Deemed Provisions – CI 67 Matters to be considered by local Government

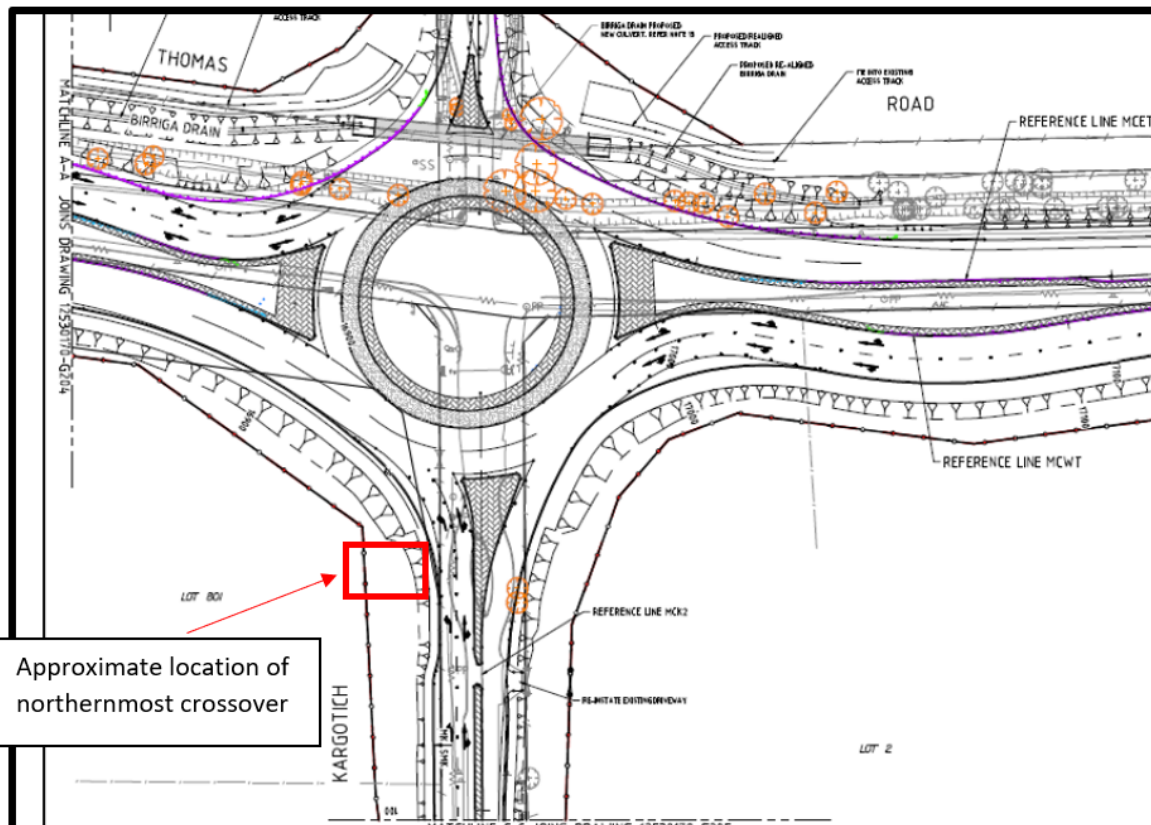
n) the amenity of the locality including the following –	YES	NO	N/A
I. Environmental impacts of the development	<input checked="" type="checkbox"/>	<input type="checkbox"/>	<input type="checkbox"/>
II. The character of the locality			
III. Social impacts of the development			
<p>Comment:</p> <p>The proposal would operate 24 hours per day, seven days a week. Due to the existing traffic volumes on both Kargotich and Thomas Road, it is considered that the proposal would not adversely impact on adjoining landowners by way of traffic noise due to the additional traffic numbers provided within the Traffic Impact Assessment.</p> <p>It is acknowledged that additional noise would be resultant from the operations of the facility. The EPA Guidelines require a separation distance of 100m between service stations and sensitive receptors. In this case, the proposal is compliant with this requirement.</p> <p>An Acoustic Assessment has been provided as part of the application detailing noise sources as Mechanical Services; Tyre Inflator beeper; Car and truck doors closing; and breakout noise from veterinary clinic. The closest sensitive receptors are detailed in the report as per the plan below:</p>

The acoustic assessment uses a modelling programme to calculate noise levels from different sources to determine compliance. The results show that compliance with the noise levels is achieved.

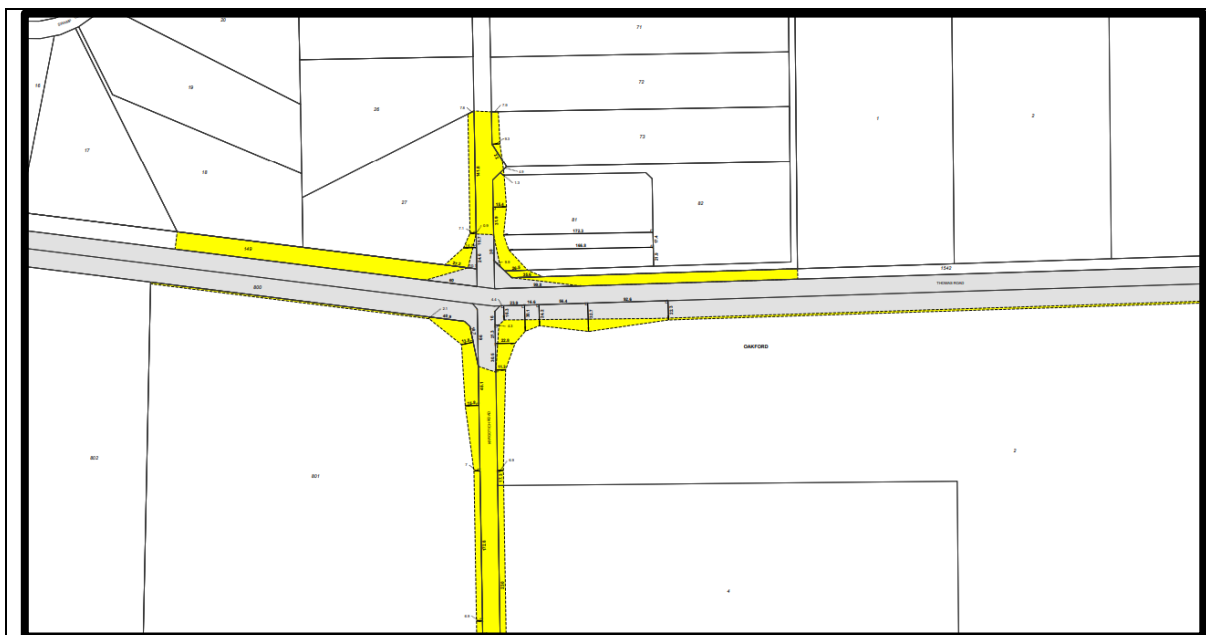
s) the adequacy of –	YES	NO	N/A
I. The proposed means of access to and egress from the site; and	<input checked="" type="checkbox"/>	<input type="checkbox"/>	<input type="checkbox"/>
II. Arrangements for the loading, unloading, manoeuvring and parking of vehicles			
<p>Comment: Thomas Road is classified as a Primary Distributor and operates under the speed limit of 80km/h in the vicinity of the subject site. The speed limit is reduced to 70km/h to the east of the Kargotich Road intersection.</p> <p>A Traffic Impact Assessment (TIA) has been submitted as part of the application which details that Thomas Road (west of Kargotich Road) carried approximately 17,846 vehicles per day (vpd) on a regular weekday in 2019/20 with the morning peak between 7:00am and 8:00am being 1,525vph. The afternoon peak was recorded at 1,792vph between 4:00pm and 5:00pm.</p> <p>Kargotich Road is classified as a Regional Distributor with a speed limit of 90km/hr in the vicinity reducing to an advisory (yellow sign) 40km/h on the approach to the Thomas Road intersection and increasing to 80km/h to the north of the intersection. Kargotich Road carried approximately 3,272vpd on a regular weekday in 2019/20 with the morning peak of 261vph between 7:00am and 8:00am and the afternoon peak of 349vph between 4:00pm and 5:00pm.</p> <p>According to MRWA mapping, Thomas Road is a RAV 7 network which can accommodate vehicles up to 36.5m in length and Kargotich Road is a RAV 3 network which can accommodate vehicles up to 27.5m in length.</p> <p>The proposal provides one full movement crossover with separate left in/right in lanes for entry and separate left out/right out lanes for exit and one left turn only crossover on Kargotich Road.</p> <p><i>Road Upgrades:</i></p> <p>Thomas Road is the subject of an 'under construction' safety project of MRWA which specific to this application includes the construction of a dual lane roundabout at the intersection of Thomas Road and Kargotich Road. The application details that the proposal has been designed to accommodate these upgrades. This work is anticipated by MRWA to commence later this year. As previously stated, MRWA have objected to the proposal, one of the reasons being the proposed northernmost crossover would be located within the functional area of this roundabout. The concept plan for the roundabout with the approximate location of the northernmost crossover is depicted below:-</p>

Section 2.4.4 of MRWA Driveway Guidelines requires driveways to be located *“as far as practical from intersections to minimise points of conflict and confusion”*. It also states that driveways shall not be permitted within the functional area of a future intersection where a roundabout will be required that is not signalised or planned to be signalised within 10 years of the development. The submission of MRWA states that *“the siting of the northernmost driveway in proximity of the future intersection increases both the potential conflict points and decisions motorist must make, thereby decreasing safety in the vicinity of the intersection”*.

The applicant has provided a response to this, contained within **attachment 6**, concerning outlining that the MRWA Guidelines only applies to driveways on State Roads and due to Kargotich Road not being a State Road they do not apply. Officers disagree with this position. The MRS reservation extends both northwards and southwards of the Thomas Road Reserve, into the Kargotich Road Reserve. It is therefore reasonable to accept that the section of Kargotich Road to which the crossover connects is a State road. In any case, it would be a concern to disregard an issue of safety on an argument of applicability. The applicant also details that this crossover is left-out only, and their view is it would not impact on safety.

Clause 67 of the *Planning and Development (Local Planning Schemes) Regulations 2015* sets out matters to be considered as part of the assessment of an application for development approval. Specifically, Clause 67 (s) requires the consideration of the adequacy of the proposed means of access and egress. In this case it is considered that the northernmost crossover within the functional area of the roundabout would increase the risk of traffic safety for road users and as such is not supportable by Officers. Officers consider, as previously discussed, that this crossover is located onto a State Road which was the intent of its location to try to meet the land use definition of a ‘roadhouse’.

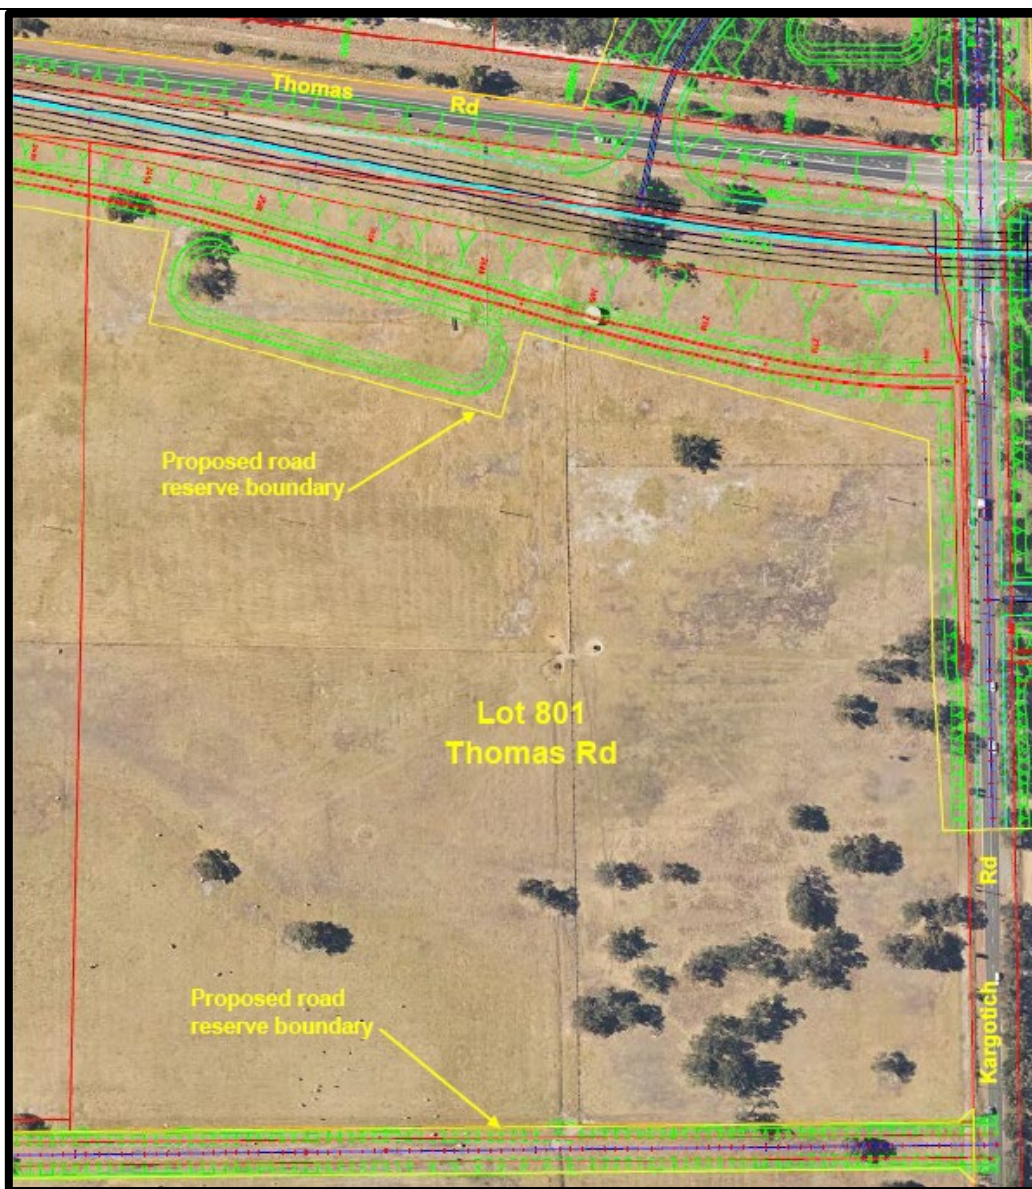
MRWA also raised concerns in relation to the impact the proposal would have on Planning Control Area 161 (PCA 161). This PCA has been declared as shown in yellow on the plan below.

The purpose of this area is to protect land for future road upgrades to allow Thomas Road to achieve its freight and regional functions. The WAPC considers that the PCA is required to ensure that no development occurs on this land which might prejudice this purpose until it may be reserved for Primary Regional Road under the MRS.
